# Columbia River Crossing Project Bridge Review Panel Final Report

February 3, 2011

*Figure 1 – CRC Constraints Limit Window of Opportunity*

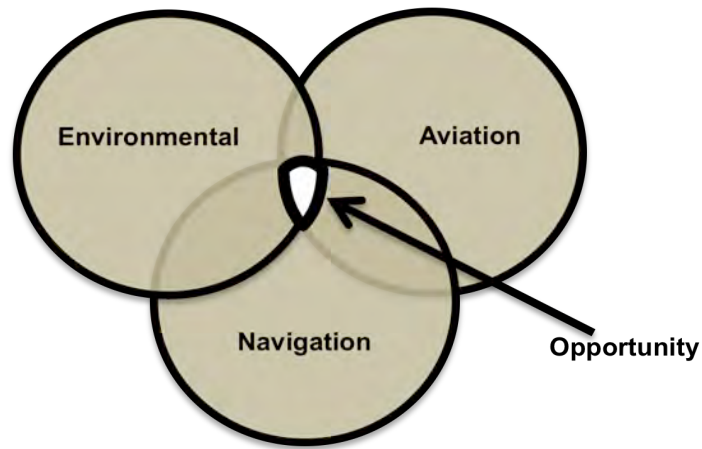
The BRP was given license to push back on some of the circles—to examine what might be possible if one or more constraints were modified. It is from this frame of reference that the BRP has performed their work and developed the recommendations that are included in this report. The BRP also came upon several "indirect" recommendations that were outside of the original scope in the context of betterment of the overall CRC project.

These interests led to multiple and often competing design constraints, as is depicted in Figure 1.

In order for the BRP to examine what might be possible if one or more constraints were modified, the panel started by exploring each constraint, how it was derived, the impacts of that constraint on the current design, and the potential benefits to the project if that constraint was modified. Through this process, the panel identified several constraints that appeared to provide the opportunity for some flexibility. These "potentially flexible" constraints include:

Figure 40 – Open-Web Box Girder Typical Section

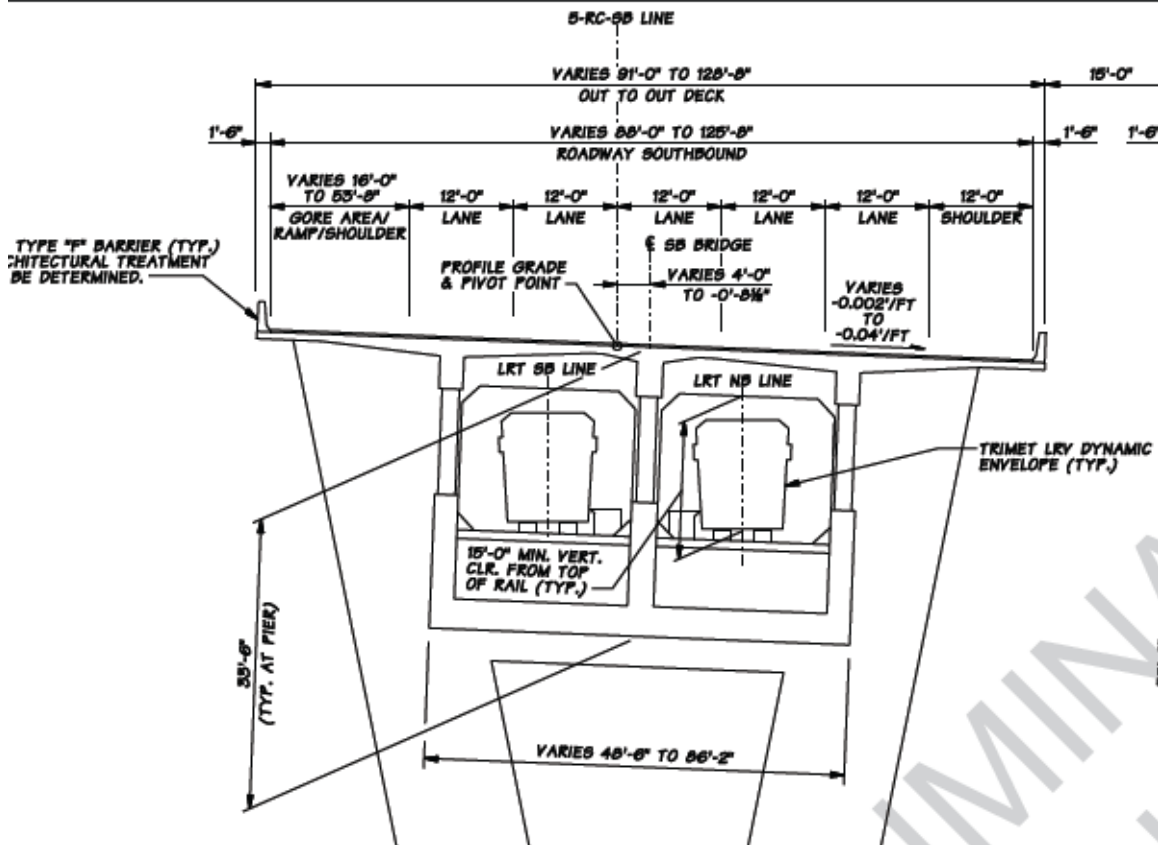
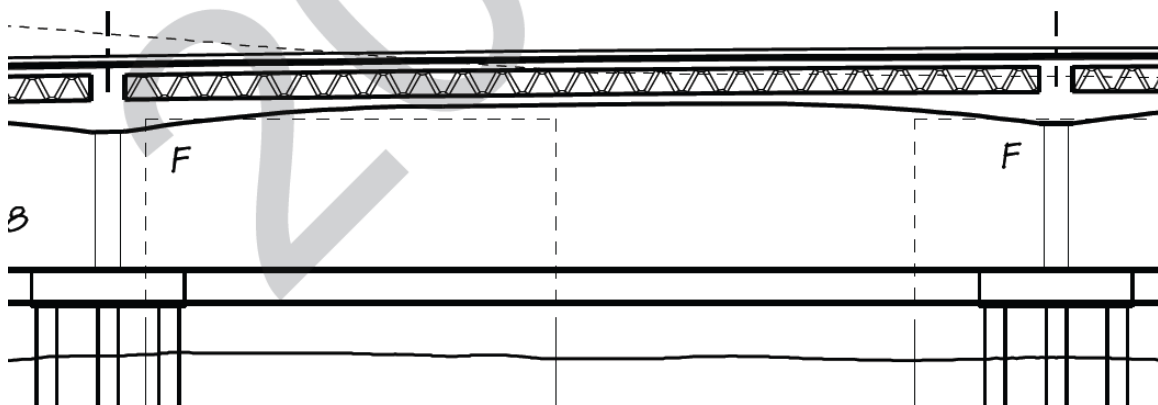
The section was developed as a conventional variable depth concrete box girder, dissected by removing a chorded section of the box girder web and replacing that section with a steel

Bridge beam design is based on the assumptions of the classical “Bernoulli” beam. A key element of the classical beam is that plane sections remain plane throughout the deflection of the beam. In the case of concrete box girders, this assumption is valid for practical dimensions of most concrete beam sections. In order to maintain plane sections, shear deformations over the depth of a web have to remain insignificant relative to longitudinal strains, or flanges otherwise have to be limited to top and bottom plate elements that will always define a plane section.

*Figure 42 – Model of Open-Web Box Girder Showing Bottom Trough, Steel Truss and Top Inverted Trough*

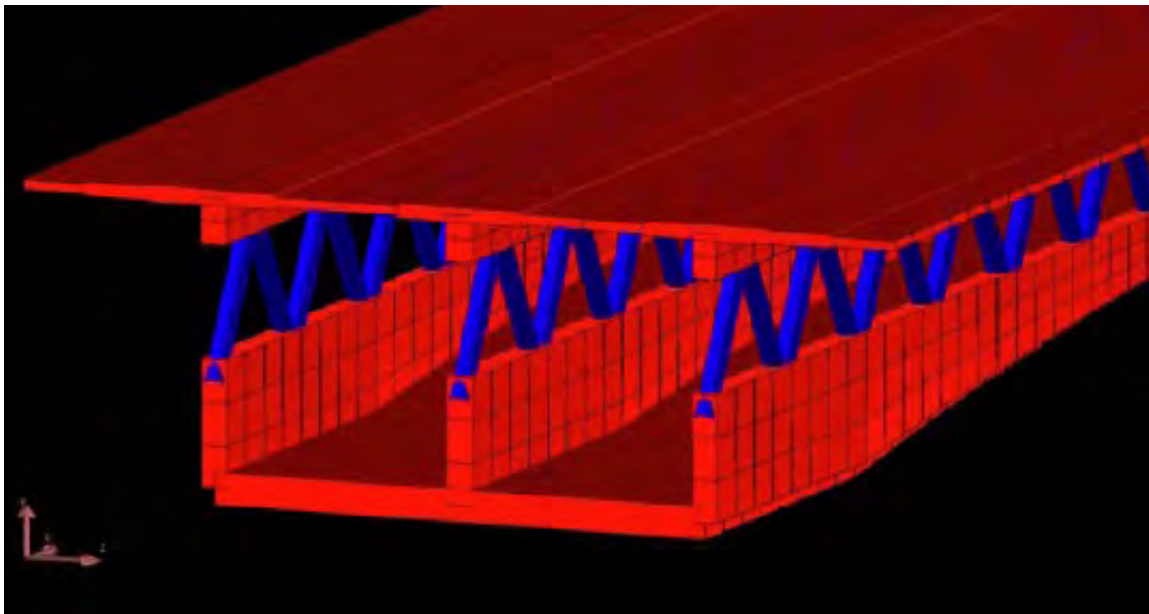
Once the core of the web is removed in the proposed open-web configuration, the section is a parallel system of three components – the bottom trough, the steel truss and the top inverted trough. The shear stiffness of these three elements differs, and the plane strain assumption is no longer valid. The result is an indeterminate cross section for bending and shear (Figure 42). This has design implications as well as construction implications (construction is discussed below).

The design consequence of the discontinuous web stiffness is that the bottom trough of the box section shown in Figure 42 will carry a proportionate share of bending and shear as a separate element in relation to the stiffness of this lower section to the entire hybrid cross section. While this can be evaluated in design, it is nonetheless a departure from classical beam behavior that has design and construction consequences. At the ultimate limit state, failure of the web system in shear will be a ‘zipper’ sequence rather than a single, ductile limit state. The lower web concrete section will draw a disproportionate amount of shear until it reaches its limit strength. Noting that this lower stem section supports the central steel web, once the concrete stem shear limit is reached, it is questionable as to whether additional shear capacity can be developed through the truss, and shear strength is likely to be limited by the weakest element in the chain of web components. This effect will require the concrete web section to be designed for a disproportionately high value of shear relative to a normal box girder.

Figure 44 – Segment Web Truss

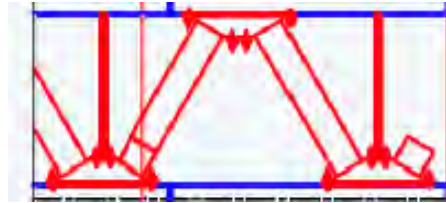
- **Geometry control of the hybrid section:** While cast in place assembly addresses the plane section issues noted with precasting, one is still constrained by the fabricated truss geometry from segment to segment. As geometry is corrected with form traveler setting, truss section dimensions will no longer suit the local geometry at the segment faces. The proposed steel section is a truss in name only – the proposed fabrication is a rigid frame (Figure 44). While bolted connections can allow modest shortening or lengthening of

diagonals and chords, the aspect ratio and rigid connections of the proposed truss sections may limit angular correction as construction progresses if corrections are significant (with the proposed truss connections, splices will be within the length of members, not at truss nodes). This geometry control operation is also a major consideration for the cycle of construction, since this adds a compound element of control not present for typical box girder construction.
